## RESPONSE TO URBIS SUBMISSION TO THE IPC - RISK ANALYSIS ISSUES

## RESPONSE TO URBIS SUBMISSION TO THE IPC

<b>Client/Project owner</b>	Jacfin
<b>Project</b>	NextGen Proposal - WtE Facility
<b>Study</b>	Response to URBIS Submission to the IPC
<b>Type of document</b>	FINAL Rev 1
<b>Date</b>	07/06/2018
<b>File name</b>	
<b>Framework</b>	
<b>Reference number</b>	LG20180606
<b>Confidentiality</b>	
<b>Language</b>	English
<b>Number of pages</b>	37

**Figure 1 – Amended Layout – Stage 1**

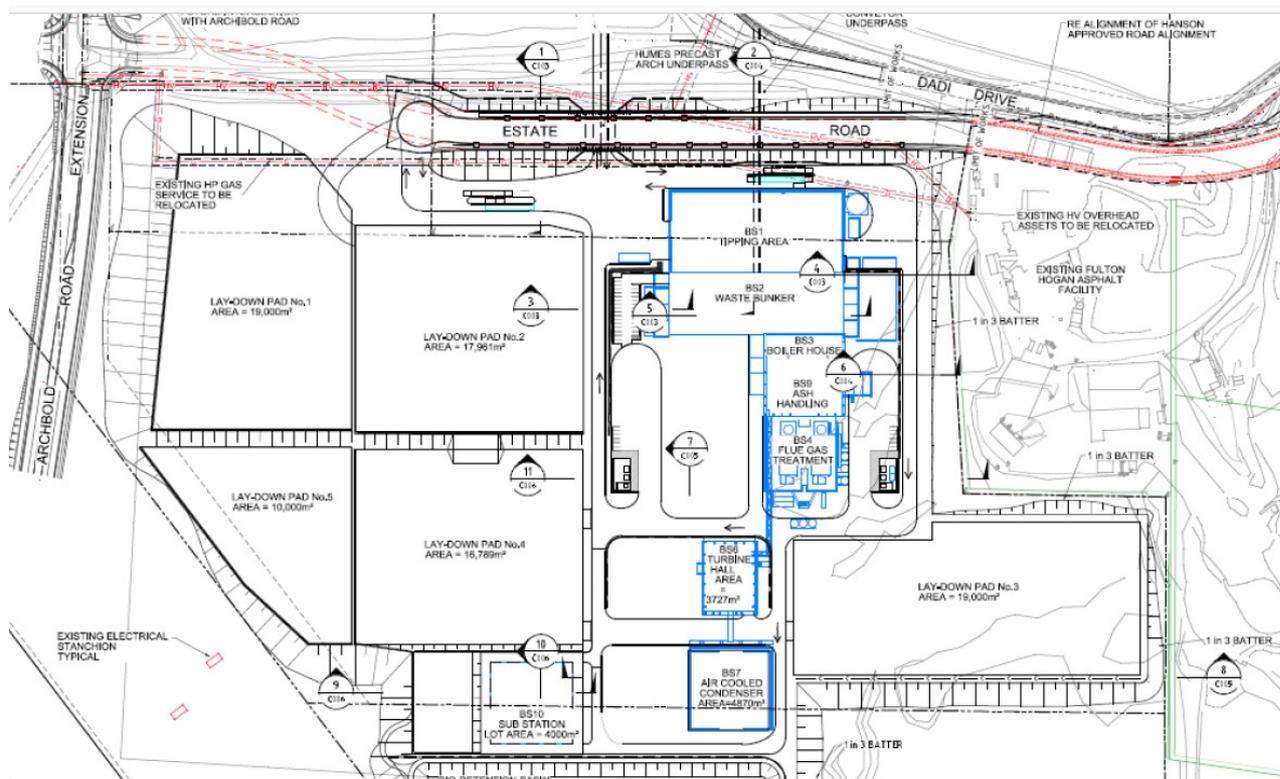
The URBIS Report does not address or provide sufficient information on risk from hard stand areas.

The amended development application submitted by The Next Generation Pty Ltd (NextGen) split the proposal into 2 stages and inferred that the Stage 1 proposal, which is the only stage for which consent is currently sought, was safer and processed less waste. However, this led to an increase in the hard stand areas of the site. This increase in area and the potential for storage of waste, and hence solid waste fires, has detrimental implications for fire and health risk.

Research conducted by SSL of existing waste recycling stations in Australia and the UK has shown that significantly large hard-stand areas are required for storage and sorting of waste at these centres. In this regard NextGen have altered the number and location of these hardstand areas in their final proposal, from 3 laydown areas (with an effective area of 77,514 m2) to 5 laydown areas, with an increase in area to 82,750 m2, and by increasing the number and size of these hardstand areas have increased the fire risk (should waste be stored and sorted on these hardstand areas in future). The fire heat flux from these hardstand areas is computed in Section 4 – Consequence Analysis of this risk review, and the risk implications in Section 7 – Risk Findings and Results and demonstrates that the NSW DPE risk criteria will be exceeded at the NextGen site boundary.

In this regard the URBIS Report does not quantitatively assess the fire risks from waste handling and storage on-site and is also silent on the boundary fire heat flux levels, and the boundary risk levels. These boundary risk levels are critical in any planning decision, and hence SSL submit that without a proper and thorough Level 3 Risk Analysis, that approval cannot be given, and that the IPC must reject the NextGen proposal on risk grounds also.

## APPENDIX C – INDIVIDUAL RISK CONTOUR PLOT

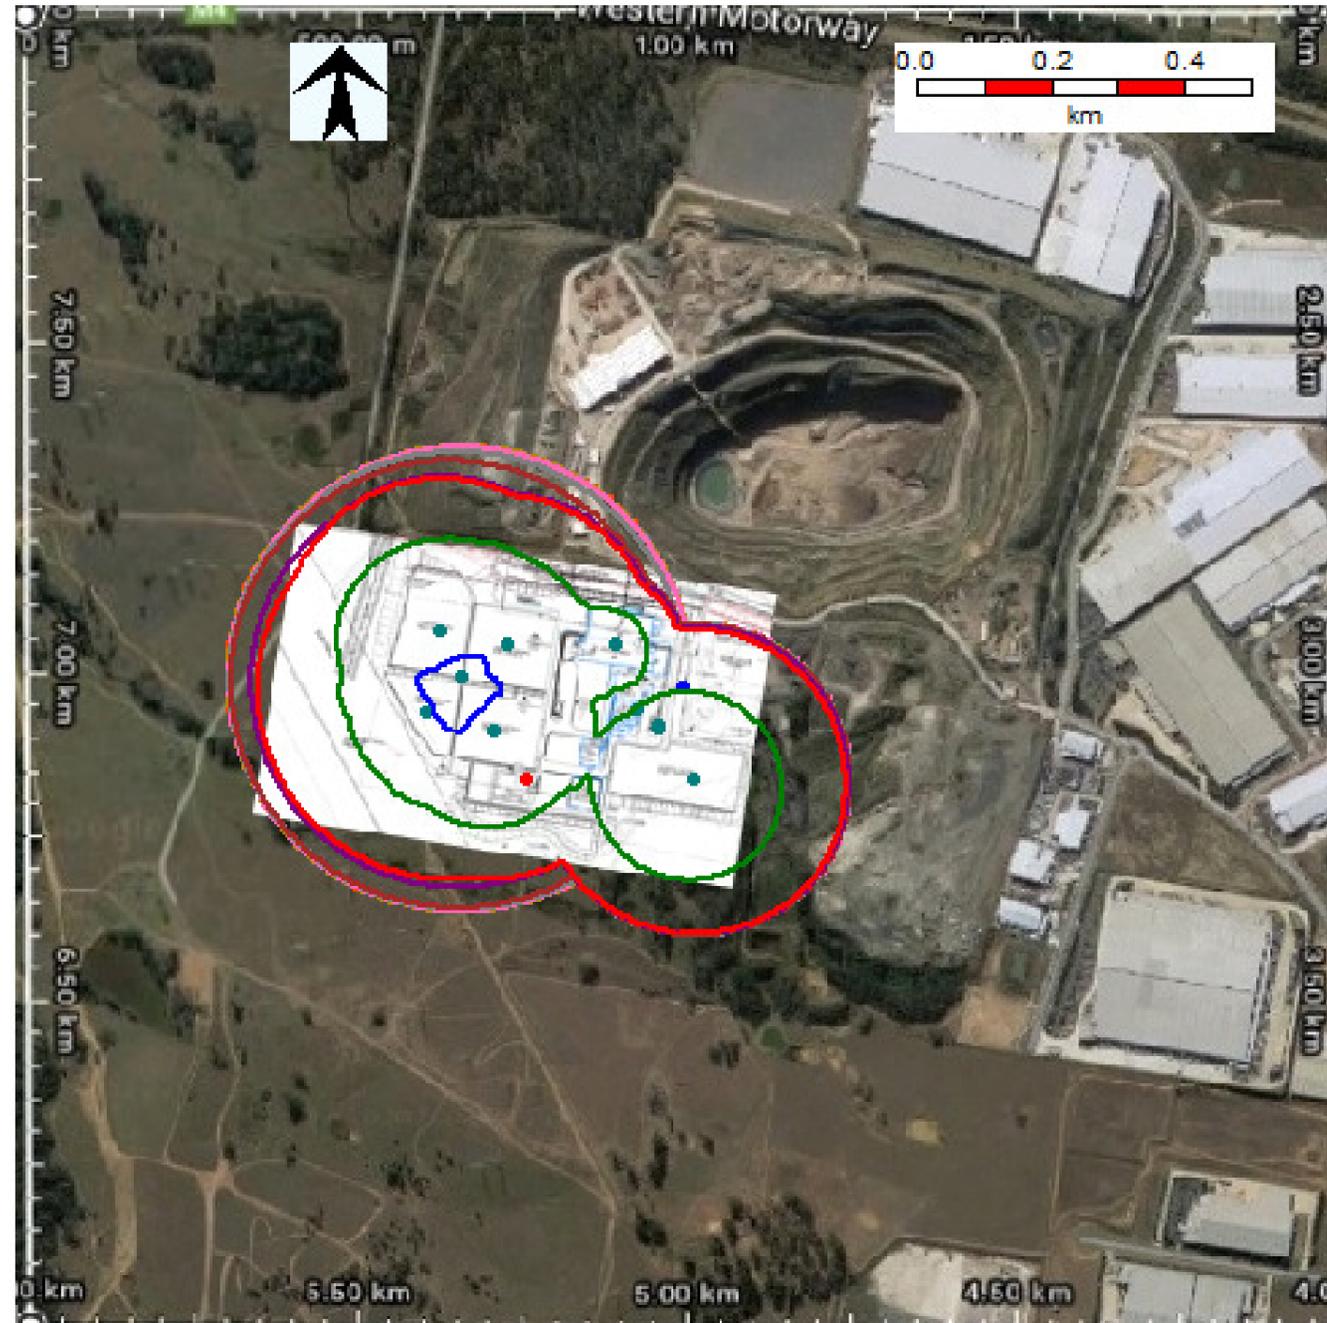
The individual risk contour for the NextGen site is depicted in Appendix C. The boundary risks are driven by the high likelihood of a solids waste fire on the laydown areas, and resultant heat flux.

While the land is currently zoned IN1 Industrial, many of the adjoining sites have commercial activities, including offices and retail areas. As such it could be argued that the boundary risk levels adopted should be 5 in a million per annum (for commercial development), and not 50 in a million per year to reflect the changing land use demographics. This would result in even greater risk level exceedances than those described earlier.

These individual risk results do not include the dispersion effects of toxic combustion products that would emanate from such fires, and their short – term inhalation and injury effects on the surrounding industrial, commercial, and residential areas. As stated in the original PHA, this aspect requires further study and quantification.

1. **Individual Fatality Risk** - Risks from the NextGen proposal exceed the NSW DPE criteria for industrial development of 50 in a million per annum, as shown in the Individual risk contour plot (Appendix D). As such, the proposal may be rejected on risk grounds alone. URBIS have not addressed this issue in their response report.

SSL has demonstrated that the NextGen proposal exceeds the NSW DPE criteria for individual risk at the boundary (see Appendix D of this report) and that the potential for waste to be stored in these hard stand areas represent a significant fire and health risk – so the phrase “no increase in risk of harm to human health or the environment “is unsubstantiated by the proponent and URBIS – in the context of individual and societal risk.
